**ALL V12 ENGINED VEHICLES****ITEM: 29****12 REVISED GASKET AND FIXING BOLT (FASTENER) PACKAGE**

A revised gasket and fastener package has been introduced on production for V12 engines to overcome complaints of oil leaks in service.

## XJ-S & S.III V12

### 12 OIL PUMPS

FIG 1

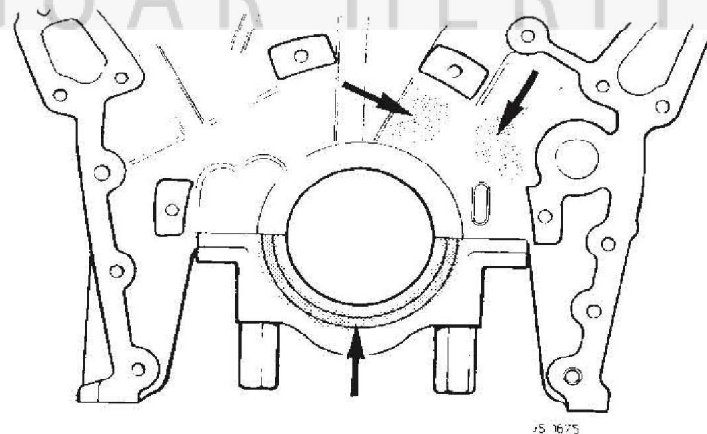
To improve quality, Jaguar is now using an alternative supplier for the V12 oil pump.

In most cases, the new pump can be used as a direct replacement with no modification to the block; however, in some cases, a foul condition may exist between the pump and certain areas of the old sand-cast block. To check for any foul condition, the pump should be offered in the correct position to the mounting bosses. If it lies flat against the bosses, the condition is correct. If the pump lies proud of the bosses, material should be removed from the foul area of the block (refer to shaded areas in Fig. 1 for possible foul areas) by careful use of a rotary file or similar implement.

Care should be taken when removing material to ensure that swarf produced by the operation is completely cleared from the area and that no other part of the engine, i.e. crank, main bearing, is damaged during the operation.
